DART AEROSPACE LTD		Work Order:	101935
Description: Crosstube Assembly (205/212/412 High Fwd)		Part Number:	D212-664-141
Inspection Dwg: D212-664-141 Rev: D		Page 1 of 2

DRAWING NO. D212-664-141	TITLE XTUBE ASSY (205/212/412 HI FWD)	REV. D	DART AEROSPACE LTD ENGINEERING ORDER		D.E.O. NO. D212-664-141-D-1	SHEET NO. SHEET 1 OF 2	SCALE NTS
DRAWN	CHECKED	MP	MFG. APPR.	ER	APPROVED	MP	DE APPR.
DATE 11.04.07	DATE 11.07.11		DATE 11.04.12		DATE 11/04/12		DATE 11.04.12

ADD AN INSPECTION WINDOW TO UNDERSIDE OF CROSSTUBE.

REPLACE MAGNOBOND WITH PROSEAL.

**D212-664-141/-141B
ASSEMBLY DETAIL**

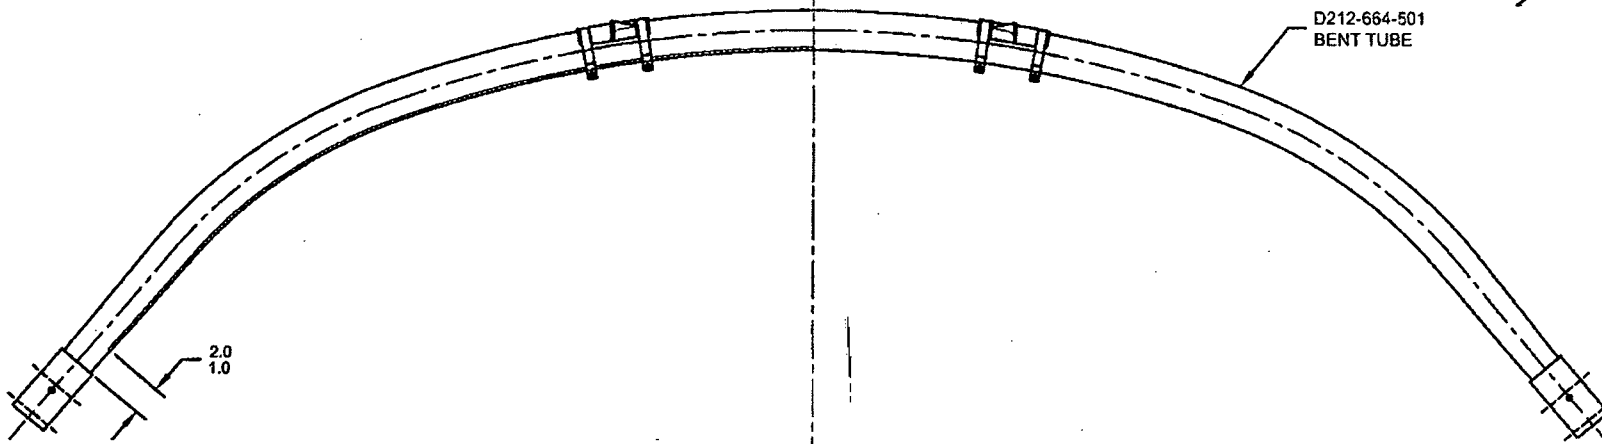
PURPOSE:

NOTES 2 OF SHEET 1 IS AMENDED AS FOLLOWS:

MASK AREA PRIOR TO PAINTING,
REMOVE MASKING AFTER PAINT
AND APPLY CLEAR COAT

- 2) FINISH: CHEMICAL CONVERSION COAT PER DART QSI 005 4.1
PRIME INSIDE AND OUTSIDE PER DART QSI 005 4.2
MASK UNDERSIDE OF CROSSTUBE AS SHOWN (HATCHED AREA) AND
PAINT OUTSIDE PER DART QSI 005 4.2
REMOVE MASKING AND APPLY CLEAR COAT
